**Committee of Experts on the Transport of Dangerous Goods
and on the Globally Harmonized System of Classification
and Labelling of Chemicals****Sub-Committee of Experts on the Globally Harmonized
System of Classification and Labelling of Chemicals****Twenty-seventh session**

Item 3 (a) of the provisional agenda

Classification criteria and related hazard communication:**work of the Sub-Committee of Experts on the Transport of Dangerous Goods (TDG)****Correction to Figure 2.1.3: Procedure for assignment to a
division in the class of explosives****Transmitted by the Institute of Makers of Explosives (IME) and the
Sporting Arms & Ammunition Manufacturers' Institute (SAAMI)¹****Introduction**

Revised Figure 2.1.3

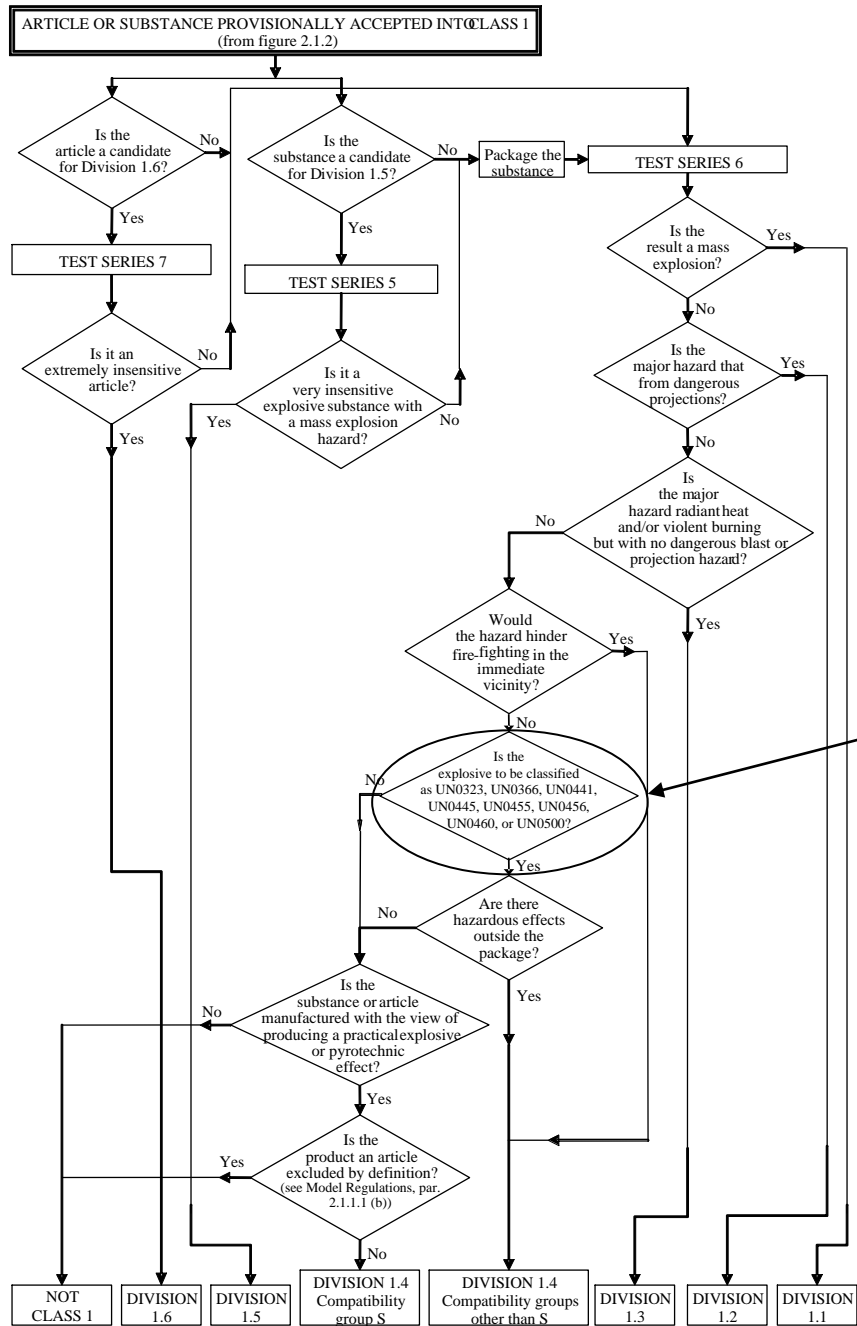
6. A discrepancy was found in Figure 10.3 of the Manual of Tests and Criteria as follows. Box 32 asks the question “Would the hazard hinder fire-fighting in the immediate vicinity?”, which is determined by the 6(c) test. A “yes” answer to box 32 flows to box 34, which is acceptance into Division 1.4 other than Compatibility Group S. A “no” answer to box 32 flows to box 33, which asks the question, “Are there hazardous effects outside the package?”. Box 33 thus implies that the 6(d) test must be applied to all items that give a “no” answer in box 32 before moving on to potential classification as Division 1.4 Compatibility Group S. Such items would be all items that are candidate for any 1.4S entry, not just those entries to which SP 347 applies. This is not correct.

7. To resolve this issue, document ST/SG/AC.10/C.3/2014/1 proposes to reference the applicability of SP 347 in the flow chart of the Manual of Tests and Criteria. However SP 347 does not exist in the GHS. Therefore, a reference to that special provision in Figure 2.1.3 of the GHS is inappropriate, and a different logical argument must be used.

8. In Figure 2.1.3 of the GHS, a box should be inserted in the “No” line between the boxes that read “Would the hazard hinder fire-fighting in the immediate vicinity?” and “Are there hazardous effects outside the package?” that limits entry into latter box to those entries to be classified as UN0323, UN0366, UN0441, UN0445, UN0455, UN0456, UN0460, and UN0500. Since the transport special provision cannot be referenced, the argument can be made by referencing the UN numbers of those products which are subject to this requirement.

11. Amend Figure 2.1.3 of the GHS by inserting a new box in the “No” line between the boxes that read, “Would the hazard hinder fire-fighting in the immediate vicinity?” and “Are there hazardous effects outside the package?”. The new box should read, “Is the explosive to be classified as UN0323, UN0366, UN0441, UN0445, UN0455, UN0456, UN0460, or UN0500?”. A “yes” answer should lead to the box that reads “Are there hazardous effects outside the package” and a “no” answer should lead to the box that reads “Is the substance/mixture or article ... explosive or pyrotechnic effect?”. The proposed revision is shown in the annex to this paper.

This is the proposed new box

10. Delete Figure 2.1.3, and replace with a reference to the Manual Figure 10.3 of the Manual of Tests and Criteria.
